Access Compliance Report

Public Rights-of-Way

Intersection ID: 15247	Main Street: E_INDEPENDENCE_BV	Cross Street: EASTWAY_DR_RA	Location:	N
ADA ID: 8991BC9F91F0	Ramp Type: Perp	Initial Pass/Fail: Fail	Overall Compliance: No	Severity Score: 10

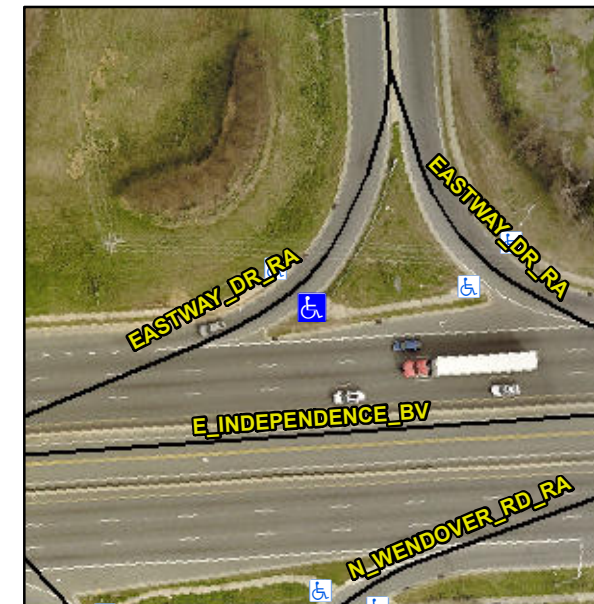
Not Found, R304.5.1, R304.5.3

Compliance	Description	Data	Compliance	Description	Data
N/A	Ramp Length (in)	68.0	Yes	Ramp Slope (%)	7.0
No	Ramp Width (in)	43.5	No	Ramp XSlope (%)	2.1
N/A	Flare Type LT	N/A	N/A	Flare Type RT	N/A
N/A	Flare Slope LT (%)	N/A	N/A	Flare Slope RT (%)	N/A
N/A	Flare Traversable LT?	N/A	N/A	Flare Traversable RT?	N/A
N/A	Landing Length (in)	N/A	N/A	DWS Provided?	N/A
N/A	Landing Width (in)	N/A	N/A	DWS Contrast?	N/A
N/A	Landing Slope (%)	N/A	N/A	DWS Length (in)	N/A
N/A	Landing X Slope (%)	N/A	N/A	DWS Full Width?	N/A
N/A	Landing Curb? (Y/N)	N/A	N/A	DWS Offset (in)	N/A
N/A	Shared Landing?	N/A			
N/A	Gutter Ponding?	N/A	N/A	Gutter Slope (%)	N/A
N/A	Gutter Lip Ht (in)	N/A	N/A	Gutter X Slope (%)	N/A
N/A	Painted X Walk1?	No	N/A	Painted X Walk2?	N/A
	X Walk 1 Direction	To NW		X Walk 2 Direction	N/A
N/A	X Walk 1 Width (in)	N/A	N/A	X Walk 2 Width (in)	N/A
	X Walk 1 Slope (%)	6.1		X Walk 2 Slope (%)	N/A
	X Walk 1 X Slope (%)	1.0		X Walk 2 X Slope (%)	N/A

Remove & Replace Entire Ramp.
